### Introduction

**Detailed comments on scheme as proposed in consultation.**

NOTE 1: Comments are mainly based on TRO drawings. Landscape drawings have generally been used to show locations.

1A Sheet 1 Lindsay Road

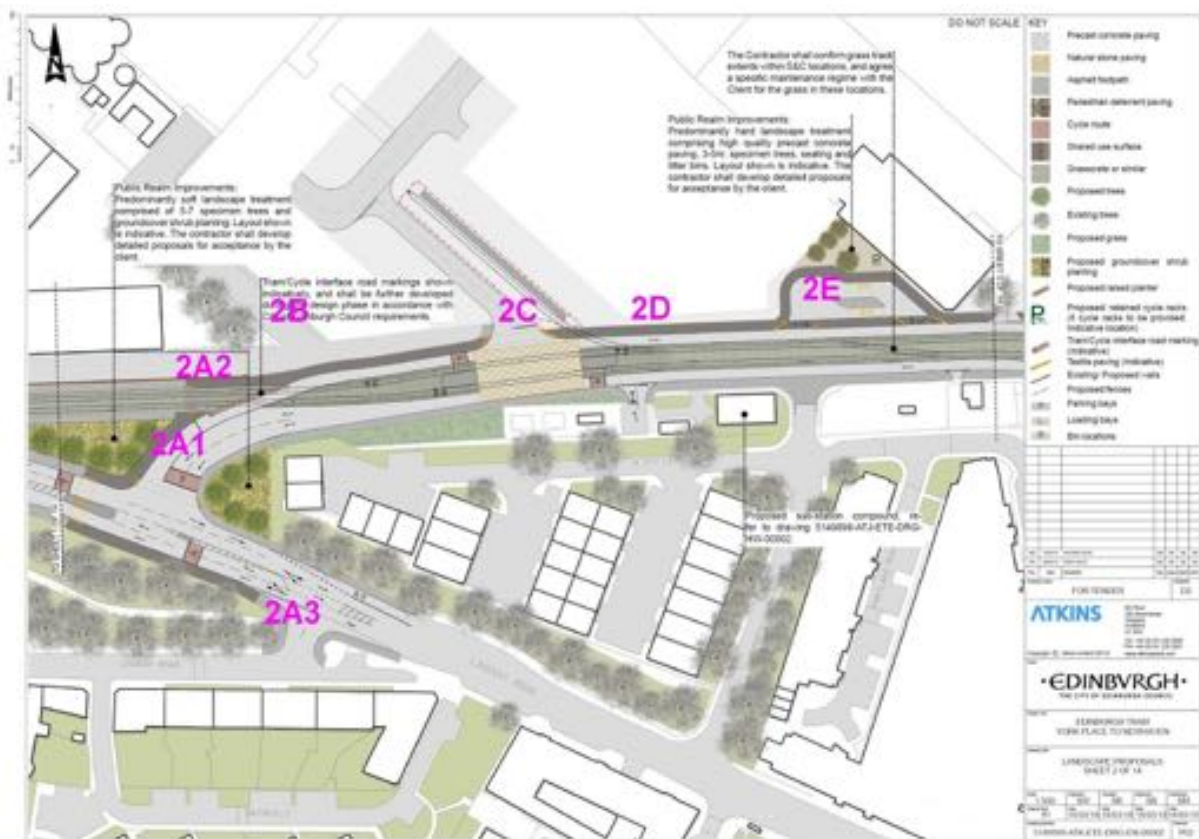
Presuming that right turns into Sandpiper Drive are permitted (there is no right turn marking shown), an advanced stop line and early cyclist release should be added to the junction to assist cyclists turning right into Sandpiper Drive. There is currently a delayed right turn phase at this junction.

If the right turn is to be banned, then alternative cyclist facilities should be provided.

There is likely to be growing demand for cycle facilities from the new developments in Western Harbour. Appropriate facilities should be provided for them to access the cycle network to the South (linking up with the North Edinburgh Path Network) and to homes and businesses in the surrounding areas.

Cycle facilities to the East and West should also be considered with space being taken if necessary from the 3 traffic lanes that are being retained on Lindsay Road.

2A Sheet 2 Melrose Drive - Junction with Lindsay Road and Hawthornvale Path

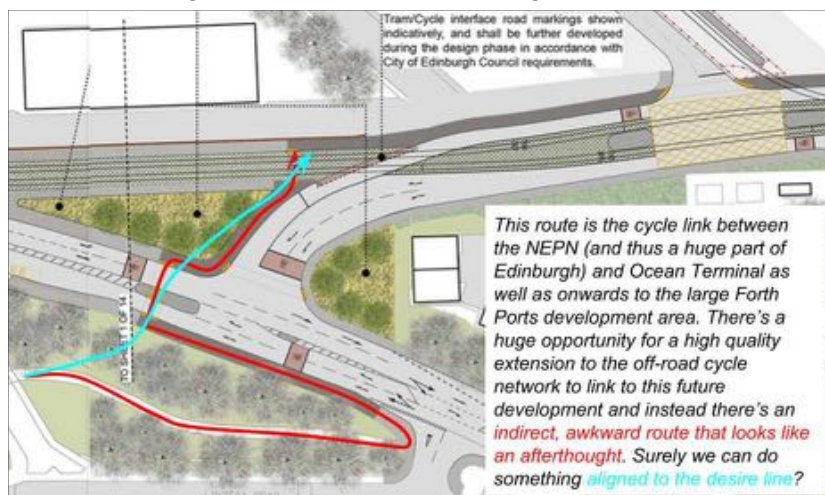
Spokes is concerned that this new road will encourage increased traffic into the area. Is its introduction required for some essential reason?

This will area will become a key cycling thoroughfare between the North Edinburgh Path Network (NEPN) and future Forth Port developments (as well as access to other areas to the East). A cycle-friendly connection is therefore of critical importance.

Spokes preferred arrangement would be for a tunnel under Lindsay Road, connecting the cycleways on the North and South sides of the road and giving easy access to and from the North Edinburgh Path Network. (See diagram below)

Alternatively, a ramp that goes straight up to Lindsay Road would be preferable to the proposed awkward, indirect routing along the footways.

2A1 The proposed connection incorporate paths, waiting areas and crossings are not sufficiently wide enough, including along the South side of Lindsay Road.

2A2 The proposed tram crossing should be unsignalised unless there are safety concerns.

2A3 The turn onto the Hawthornvale cycleway needs to be widened to a convenient angle for cyclists.

2B Sheet 2 Melrose Drive link to Sandpiper Drive

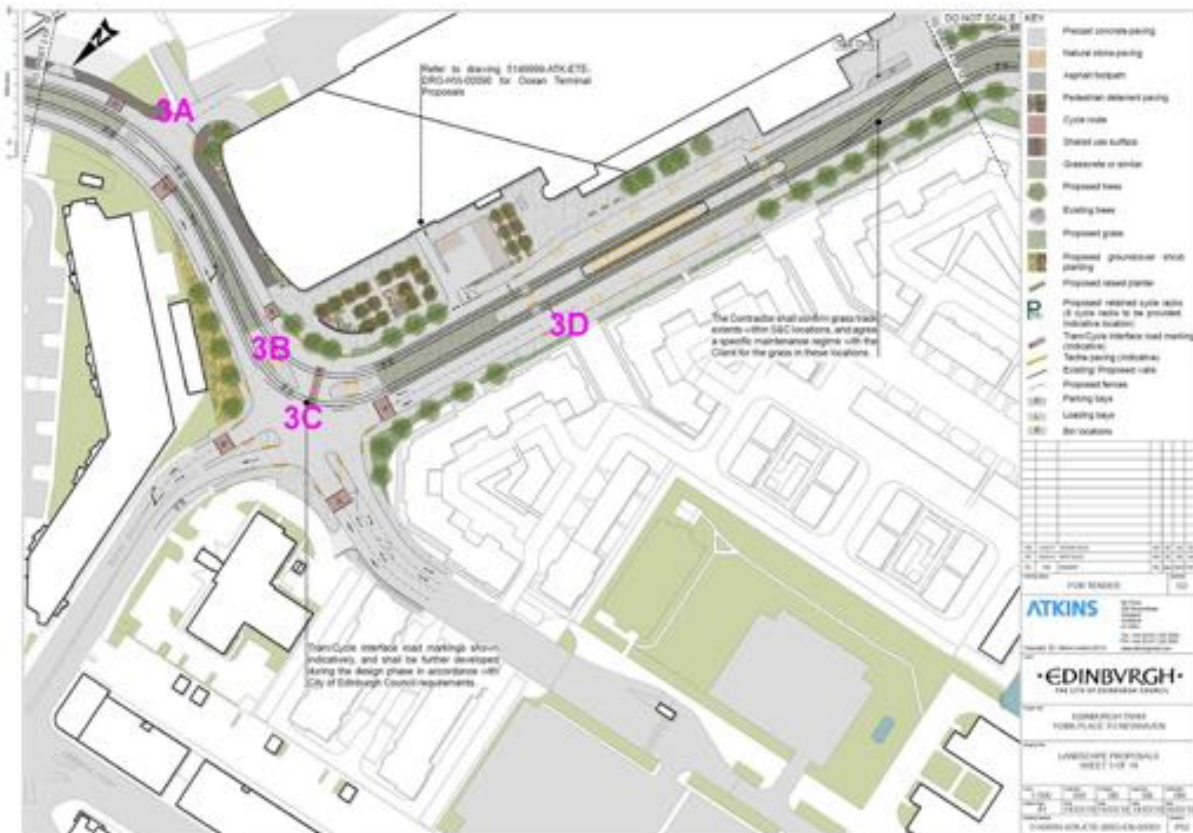
A cycle link needs to be provided to the continuation of Melrose Drive for cyclists heading to Asda and Western Harbour via Sandpiper Drive.

Cyclists need to be able to be able to cross the tram tracks at a safe angle and with signalised controls as appropriate.

2D Shared use not appropriate - should be segregated as stated in the area-wide comments (See Area Wide Comments A1).

The bus/coach stopping area needs to be re-designed to allow direct, safe transit by cycles. The stop is presumed to be infrequently used and therefore pedestrians and cyclists should have priority across the access points. If a floating bus-stop arrangement is required, then the cyclepath should have a more straightforward route than indicated and be clearly demarcated from the pedestrian areas. It should be made clear to road and cycle/footway users who has priority and the direction of approach of vehicles (eg if vehicles are turning right into the stop).

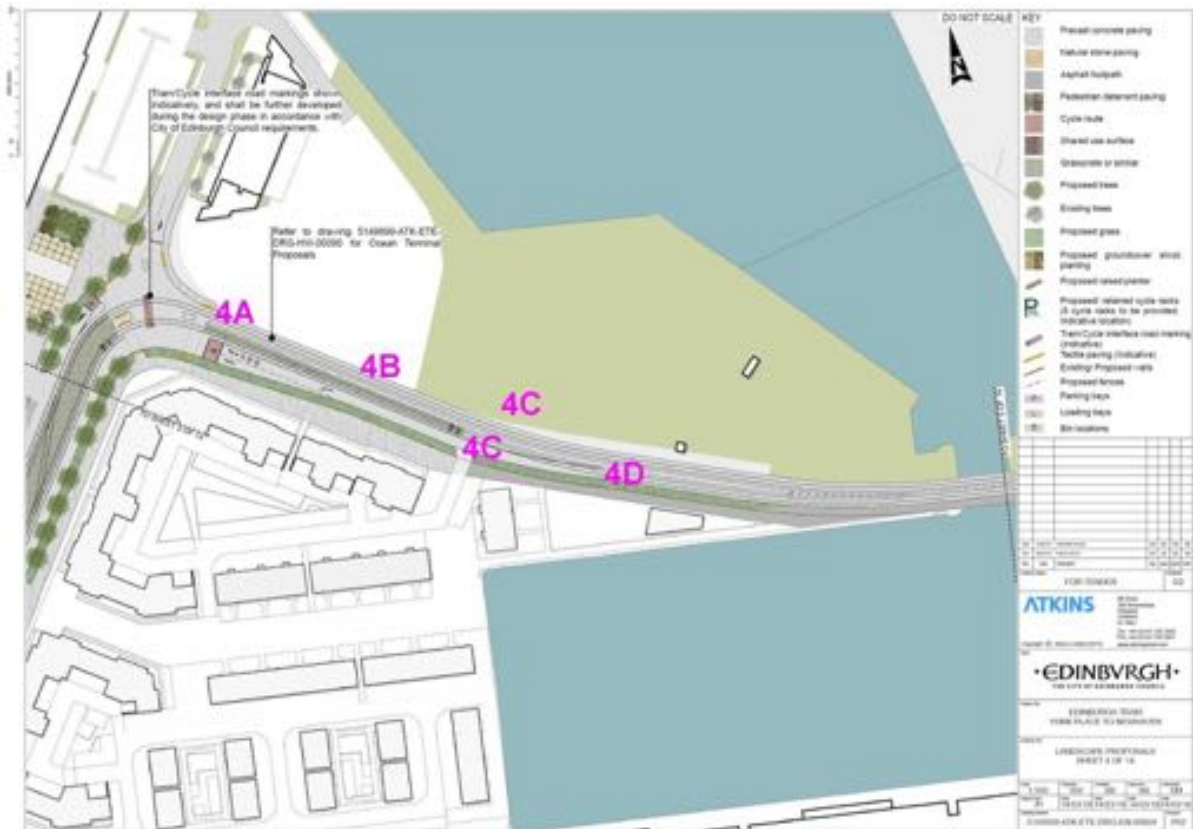
3A Melrose Drive junction with access road to rear (West) of Ocean Terminal  
A safe crossing for cyclists needs to be provided with signals as appropriate.

3B This crossing should be a Toucan with access for cyclists from Commercial Street.

3C New crossroad junction - Ocean Drive with Melrose Drive and Ocean Boulevard  
The new crossroad junction should provide safe angles for cyclists to cross, with early release at the signals. Links need to be provided to cycleways coming from Melrose and Ocean Drives.

3D Ocean Drive main carriageway alongside Ocean Terminal  
A new segregated bi-directional cycleway should be provided on the East side of the road, across from Ocean Terminal, whilst retaining access to the cycle parking.

#### 4B Ocean Drive (North) to Rennie's Isle - Carriageway width

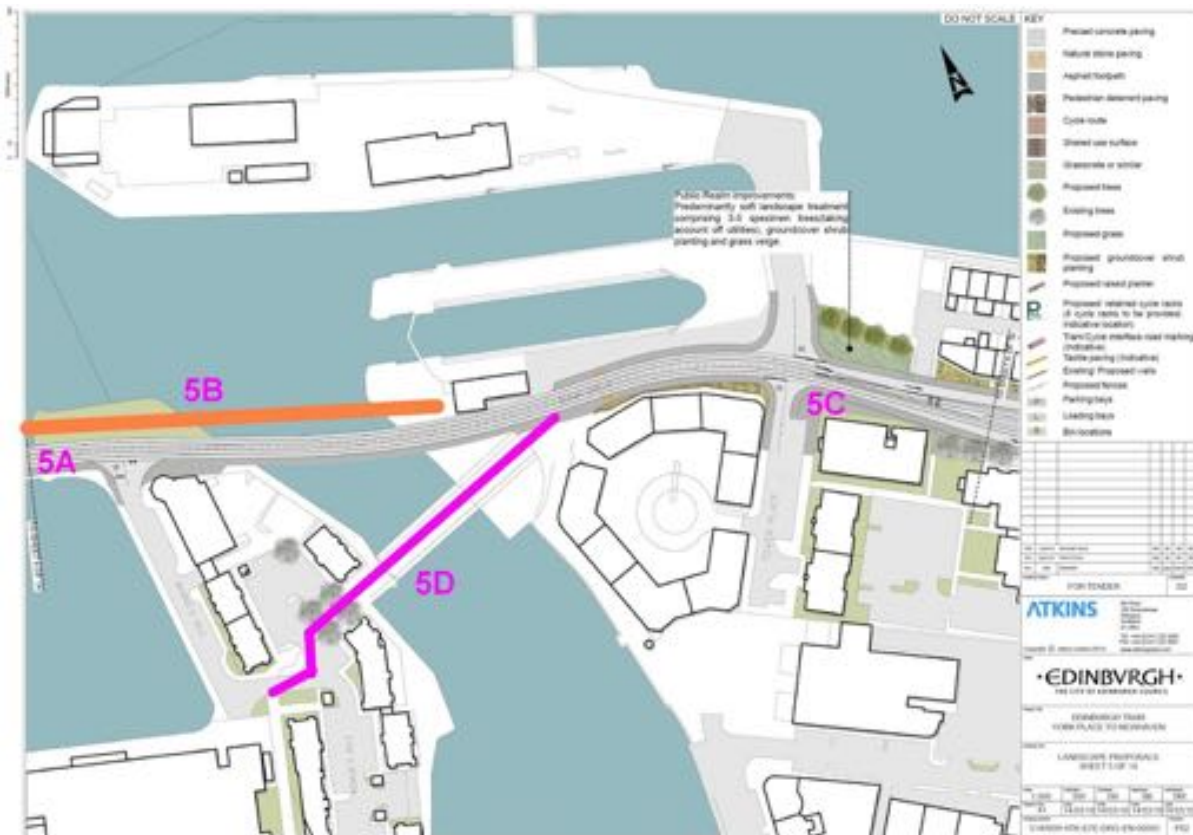
As stated in Area Wide Comments A1, segregated cycling provision needs to be included in this section. This is critical to providing a coherent cycle link between the NEPN and the Forth Ports development area.

Why is a median strip required here? It will form a barrier to free movement of pedestrians and cyclists and potentially takes up space that could be used for cycling facilities.

This section appears only sufficiently wide for the tramway, with little room between the rails and the kerb for people to cycle safely on the road. The traffic lanes should be widened to make sufficient room for cyclists - at least 1.5m.

Cycling access needs to be provided to/from the new developments to the North and South. These developments should bring a lot more active travellers to the area and developers should provide suitable facilities within their developments.

A shared use cycleway is not appropriate at this location, given the expected number of active travellers that will be moving into and passing through the area. A 2-way cycleway on one side of the tramway may be sufficient if sufficient crossing points are provided.

5 Ocean Drive (North) - Rennie's Isle to East of Tower Place

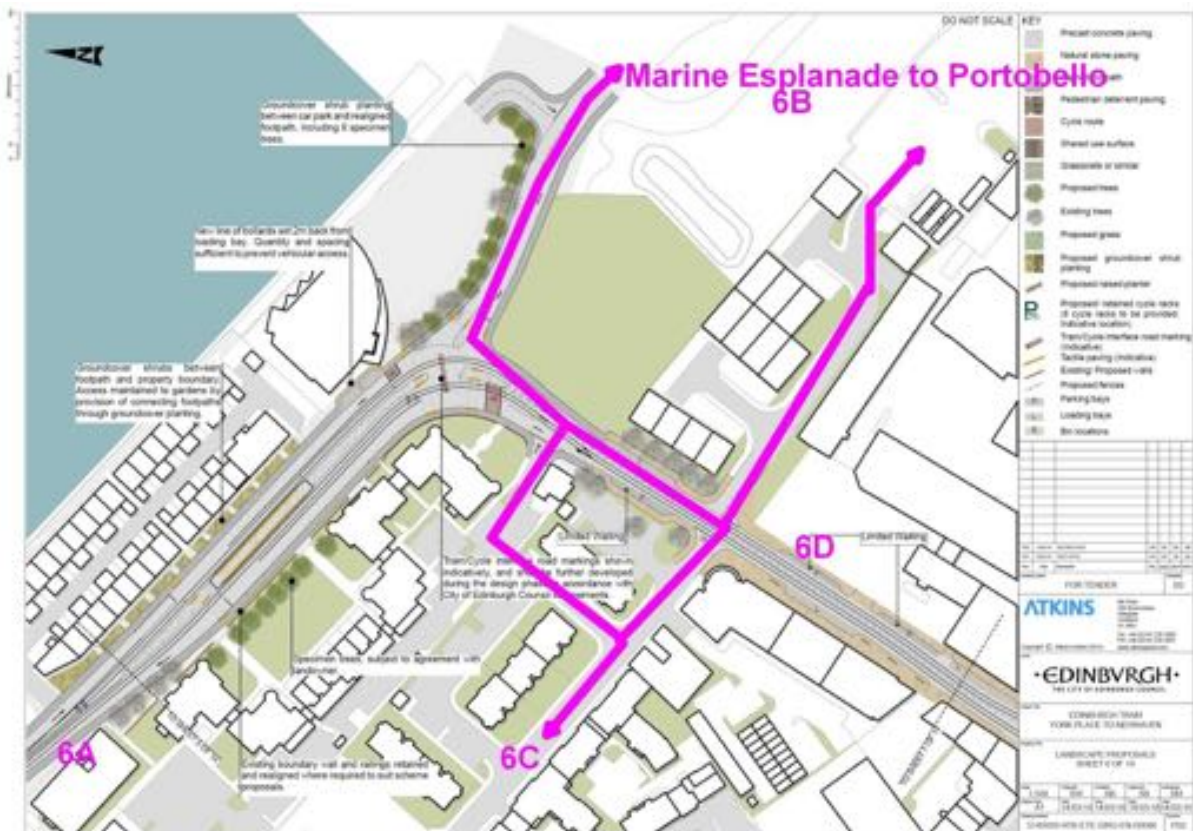
5A The tramway continues to take up much of the carriageway (as in 4) with little space for cyclists. As in 4, the carriageway should be widened or segregated/shared paths provided for cyclists.

5B Tower Place Bridge is particularly narrow and the addition of an iconic cycling bridge would make for a good solution for joining up segregated cycleways along the North side of Ocean Drive

5C The proposed junction at Tower Place, narrows considerably for Westbound users. Cyclists wishing to turn into Tower Place, should be given the option of joining the wide footway on the corner to make the left turn and continue through to The Shore.

5D Alternative/Additional Proposal - consideration should be given to providing a pedestrian and cycling crossing over the Victoria Swing Bridge to Rennie's Isle, providing a cycle and pedestrian link through Rennie's Isle to Victoria Quay, for access to the Scottish Government Offices and via the lane (that would require some resurfacing to form a suitable cycleway) along the back of Commercial Street and via a new crossing through to Ocean Terminal. (Victoria Quay is closed to through traffic, being the car parking for the Scottish Government Offices.) This would also form a useful link for cyclists south to "The Shore" as a destination, plus connections through to Warriston - Leith cycle path needs creating/improvement.

### 7 Constitution Street to Queen Charlotte Street

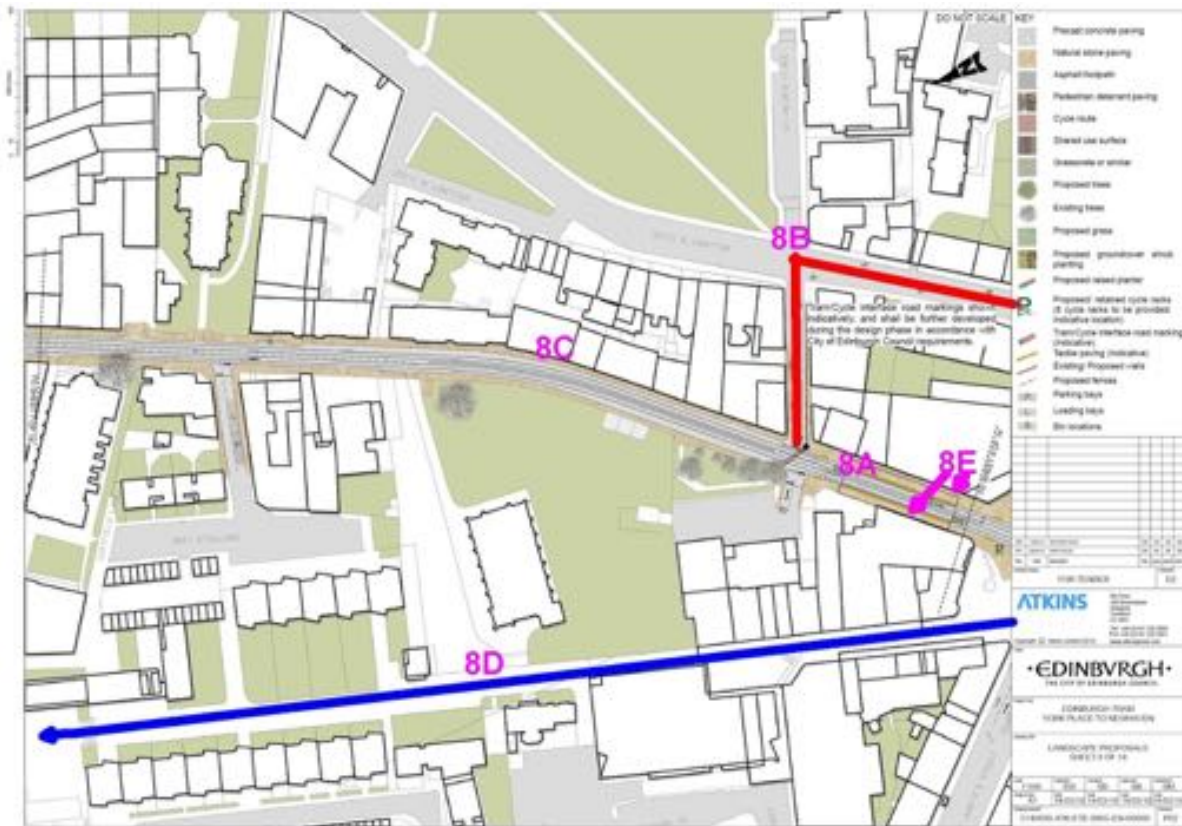
7A 2-stage right turns should be provided at Bernard St junction.

7B The extended public realm at Bernard St should allow for cycle access from Constitution Street through to Bernard Street.

7C Tram stop at junction would appear to block motor traffic heading from the Bernard Street/Baltic Street junction south into Constitution Street. Will the traffic lights have filters that will stop left or right turns when a tram is in the stop?

7D Segregated cycle facilities need to be provided and parallel alternatives considered. Space should be available as the existing roadway mostly supports at least 2 lanes of traffic in addition to parked vehicle.

7E The junction arrangement at Queen Charlotte Street needs redesigning to allow for safe cycling. The ASZs and the 2-stage bike boxes are dangerously situated in the middle of the tram tracks and the tracks appear to be only 1m from the kerb which is insufficient space for cyclists to ride safely.

7F There appears to be no median strip on Constitution Street. How will the tram wires be suspended and can the same approach be taken on Leith Walk?

8 Sheet 8 Constitution Street to Laurie Street

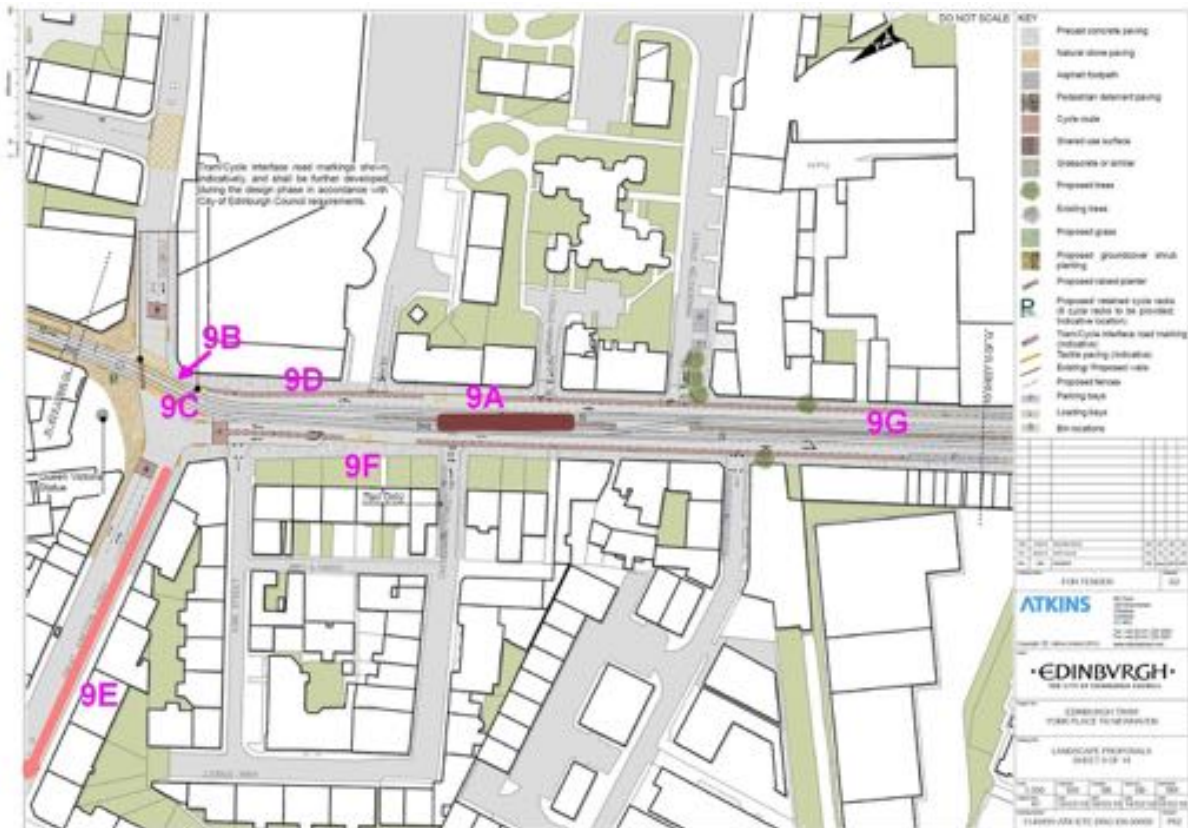
8A Spokes proposes that the tram-stop is moved to the foot of Leith Walk. This is a large open area that would provide free access for pedestrians and create a more appealing “place” than could be achieved in the constricted area at the start of Constitution Street. It would also make for a better tram/bus interchange and easier crossing for pedestrians. The space relinquished would allow space for segregated cycling on Constitution Street (where there is currently room for parked vehicles and 2 lanes of traffic) and avoid the need for the proposed alternative route via Academy and Laurie Street (8B in red).

8B The alternative cycle route via Laurie Street and Academy Street is not suitable for all ages and abilities of cyclists. It is a detour, it adds more turnings, the surface is cobbled and there is a lot of parking in what would be the cycleway. Southbound cyclists would have an unsignalised crossing of busy Duke Street whilst Northbound ones will have to make the awkward crossing at Duke Street (see Sheet 9) and make 2 unnecessary crossing of the tram tracks..

8C Segregated cycling provision should be included along the length of Constitution Street.

8D Cycle access through NewKirkgate, a historic main through-route from the Foot of the Walk, should be carefully investigated, although we appreciate there are some difficulties to overcome.

8E Another though not highly recommended option would be to allow cycling behind the tram stop walkway, should it remain on Constitution Street. There appears to be sufficient space but examination of more detailed designs would be required.

8F Further cycle links to eg to The Shore and Ocean Terminal should also be explored, for example via Great Junction Street and Henderson Street (see 9E)
